Pleasanton Unified School District	ADDENDUM 02
	Project: Lydiksen Elementary School Modernization (2021-22.14)
	Date: April 20, 2022

Subject: Lydiksen Elementary School Modernization
Pleasanton School District
Aedis Project No. 2020029.02
DSA Application #01-119816

ADDENDUM NO. 2

2 BUILDING C - FLOOR FINISH PLAN
SCALE: 1/8" = 1'-0"

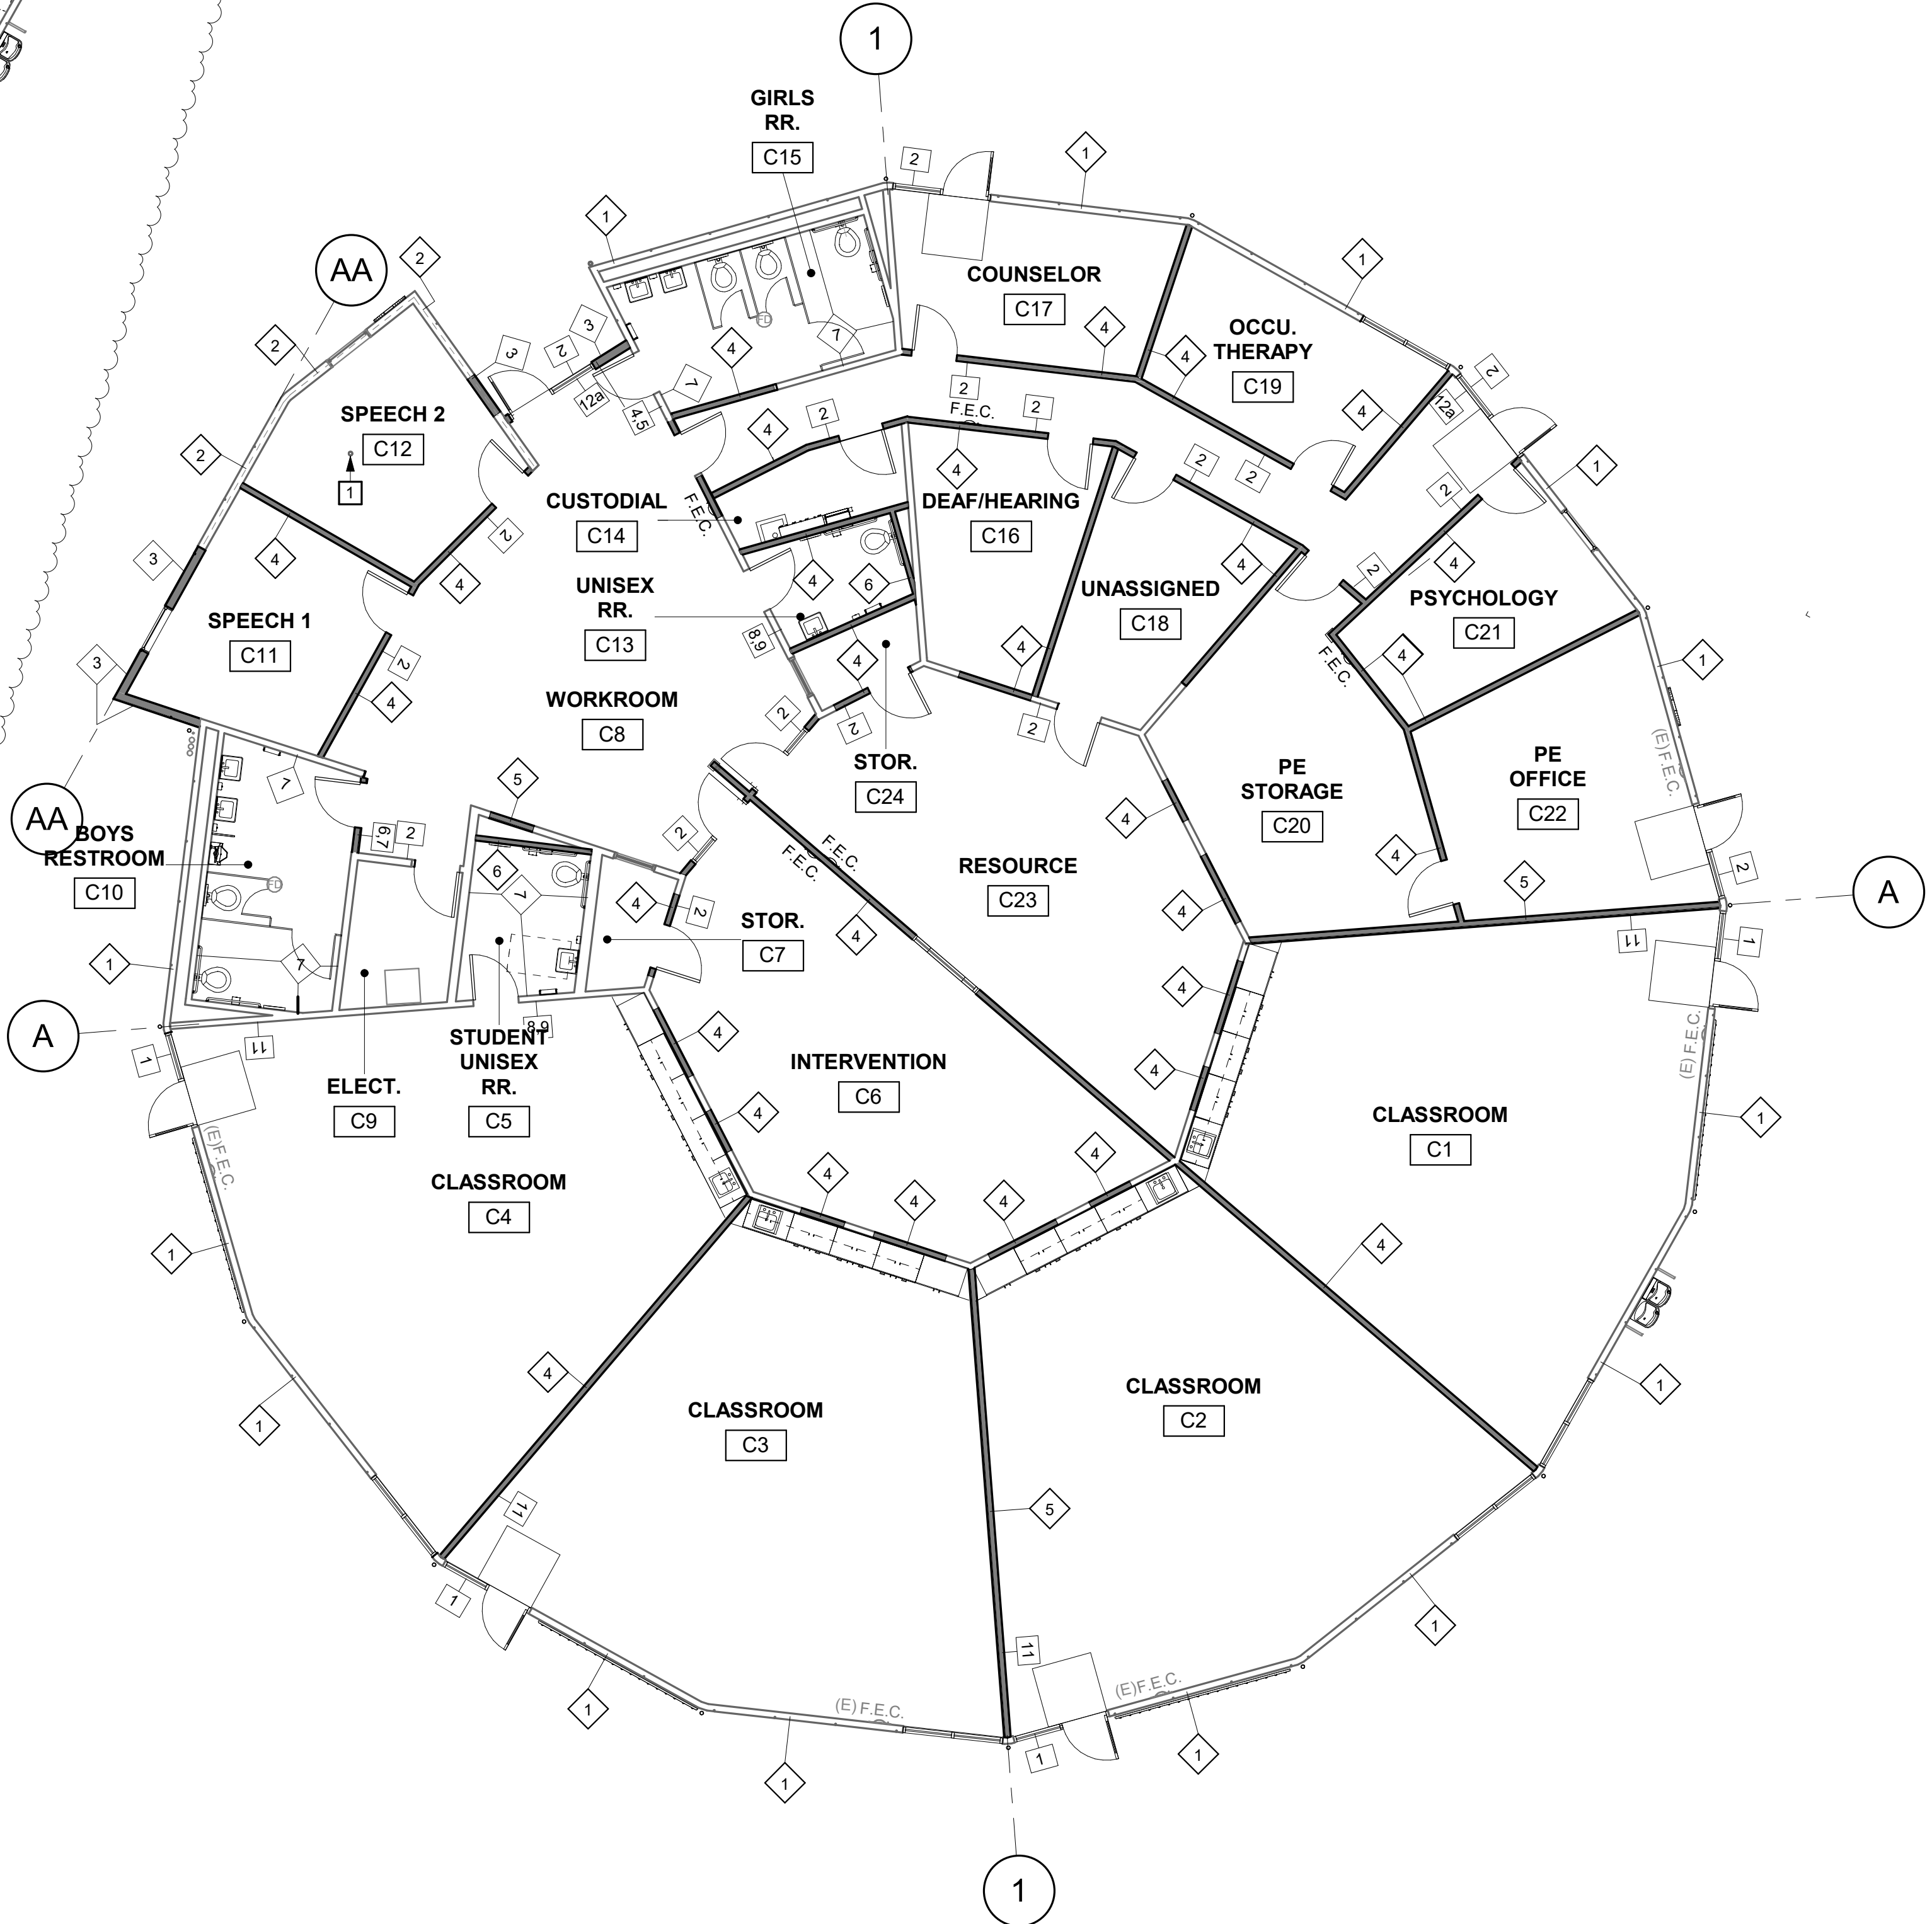
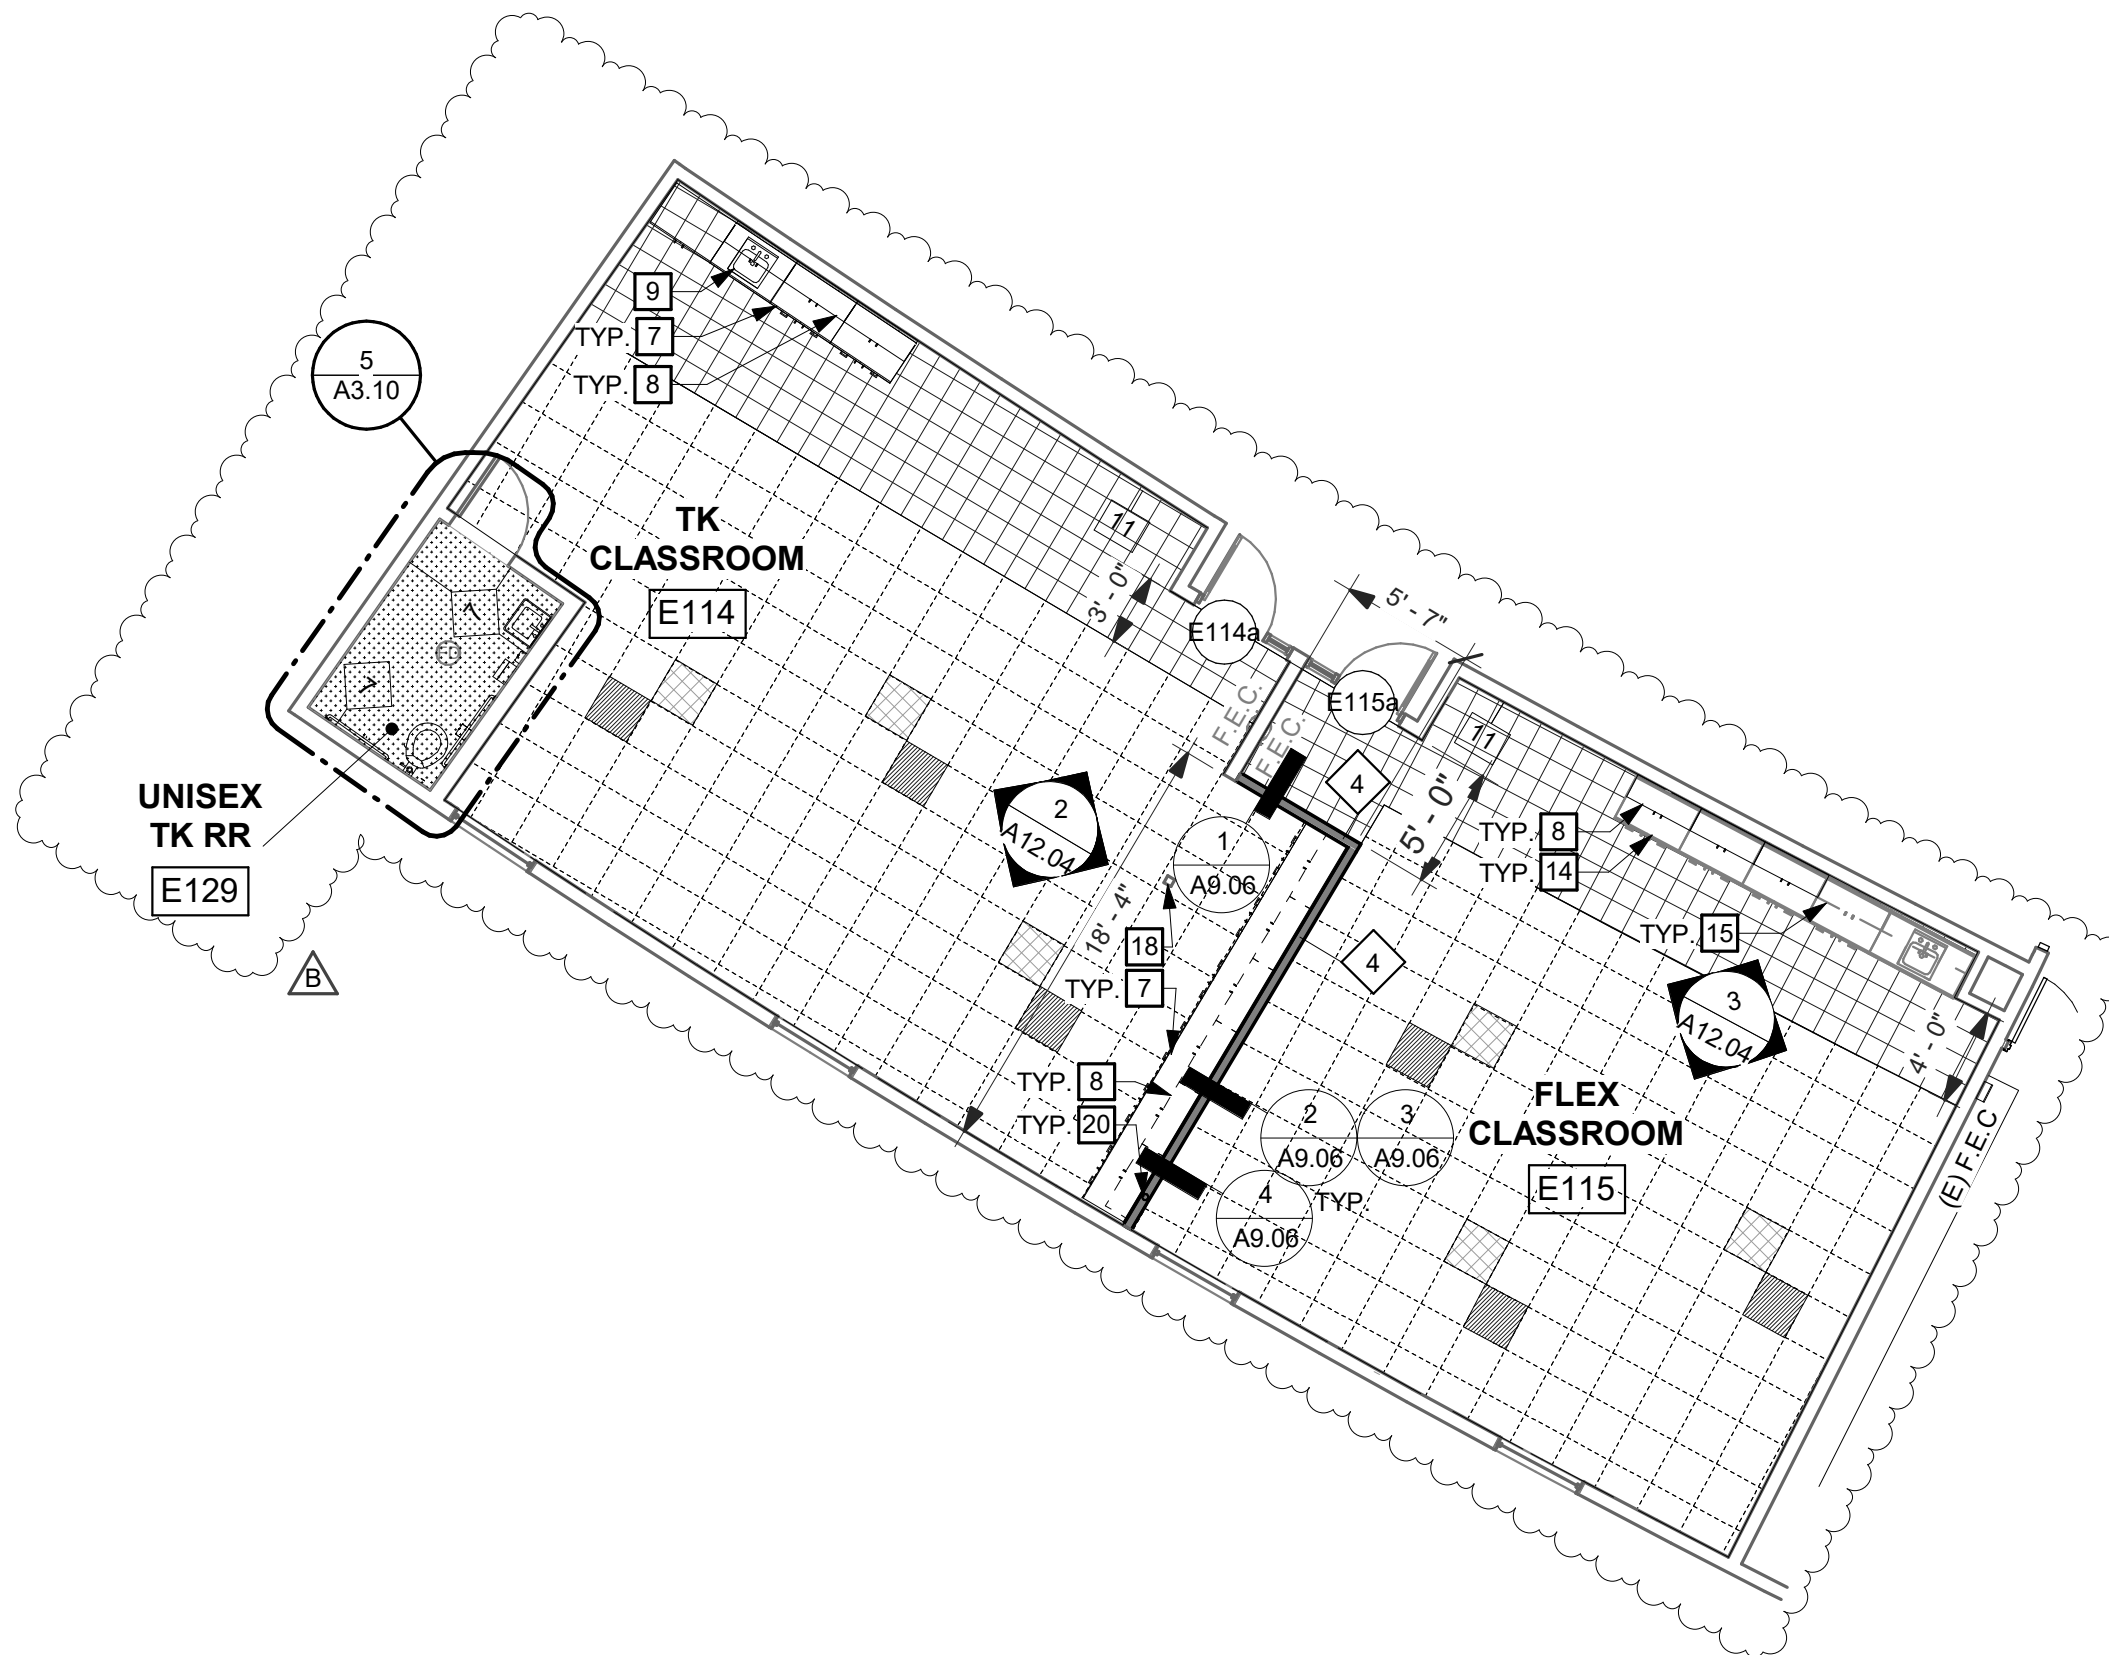
ITEM NO. 2.1: DRAWING SHEET A3.02 – BUILDING C – WALL TYPES AND SIGNAGE PLAN

Add: Building C – Floor Finish Plan per attached AD2-A3.02

Add: Finish legend per attached AD2-A3.02

AD2-A3.03

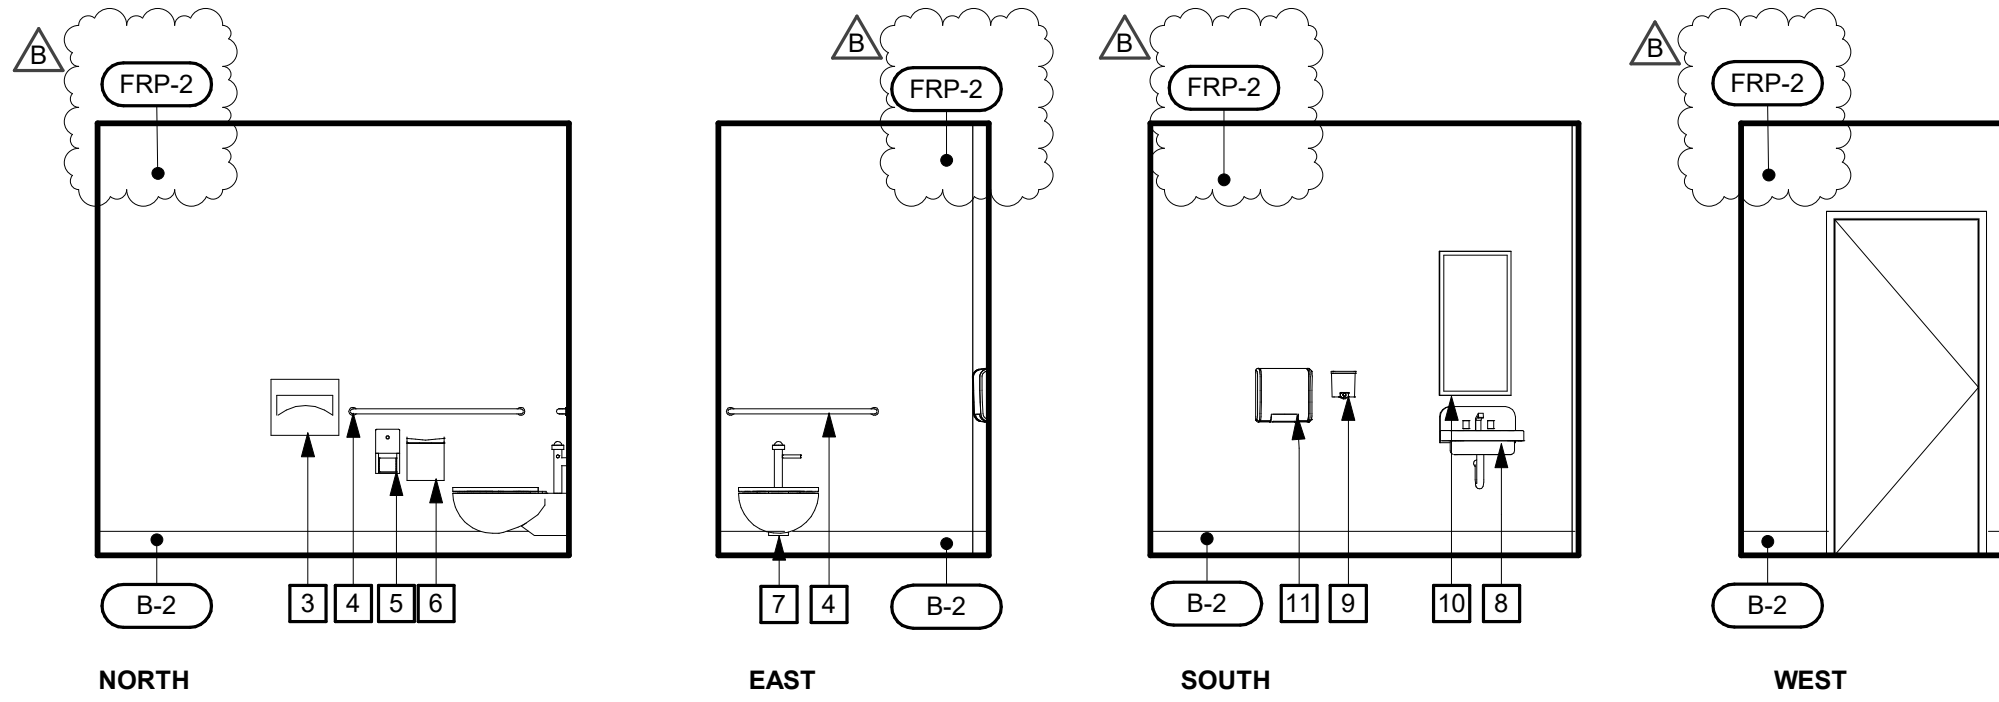
ITEM NO. 2.2: DRAWING SHEET A3.03 – BUILDING E – FLOOR & RCP DEMOLITION PLAN

Revise: Floor plan with finish legend per attached AD2-A3.03

6 STAFF RESTROOM - C13 - INTERIOR ELEVATIONS

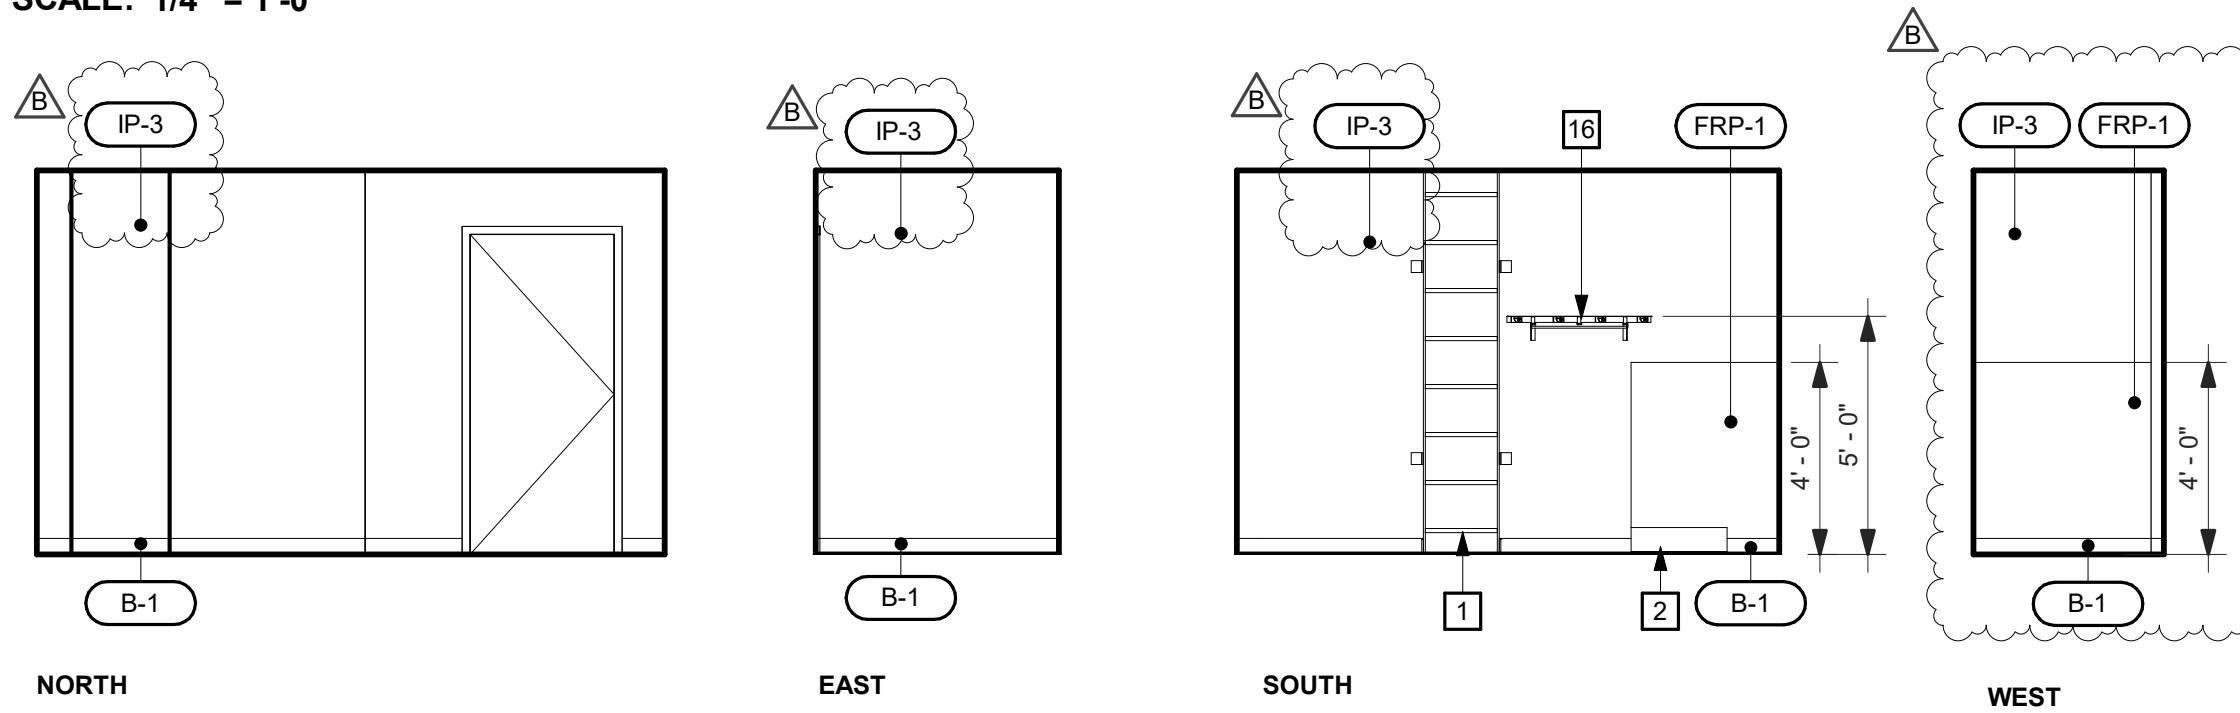
ITEM NO. 2.3: DRAWING SHEET A3.10 – ENLARGED RESTROOM PLANS & ELEVATIONS

Revise: STAFF restroom wall finish per attached AD2-A3.10

Revise: Custodian wall finish per attached AD2-A3.10
